Product Change Notification

Change Notification #: 116595 - 00
Change Title: Intel® Omni-Path Active Optical Cable (AOC) QSFP-QSFP Cable Assemblies
PCN 116595-00, Transport Media, Mechanical Strain Relief and Package Improvement
Date of Publication: November 19, 2018

Figure 1. Serial Number (SN) with date code (APEWWYYXXX)

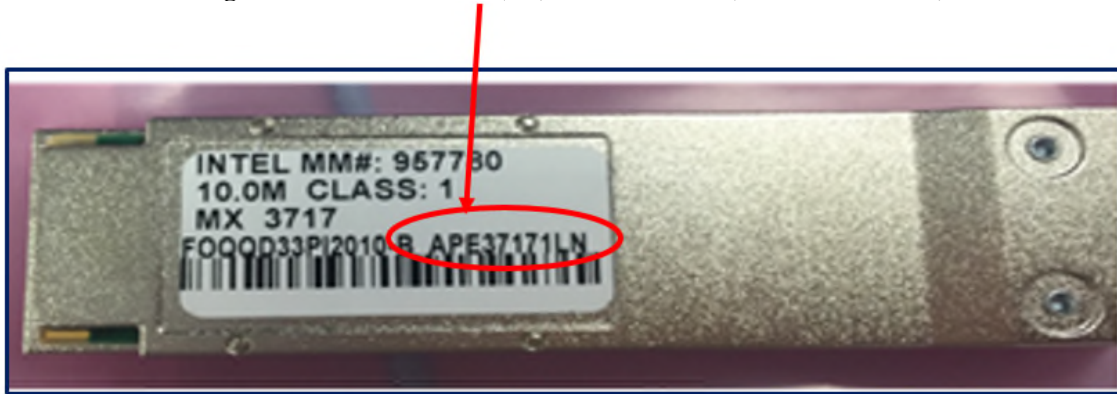
Change 1: AOC cables within the following date code range [APE3917XXX to APE1818XXX] were susceptible to damage if the cables were uncoiled using improper methods. The damage resulted when the cable jacket and ferrule rotated in the cable connector housing.

To identify the Serial Number (SN) date codes, Figure 1 details the Serial Number (SN) location on the cable connectors and the format to correctly define date codes. In the example below, the date code in the SN string APE3717XXX identifies the week (WW) as 37 and 2-digit year (YY) as 17 (2017). To correctly define date codes, look for the identified WWYY ranges.

Intel is not recommending additional customer qualification of these changes. Additionally, there is no change to the Intel Material Master (MM) numbers. Material with Serial Number date code WWYY of APE1918XXX or later incorporates strain relief improvement defined in Change 1. New packaging was implemented calendar WW40 of 2018 per Change 2.

For customers who have AOC cable material with date codes ranging from APE3917XXX to APE1818XXX in spares inventory or ready to install, please contact Intel® Omni-Path technical support at fabricsupport@intel.com to initiate an RMA.
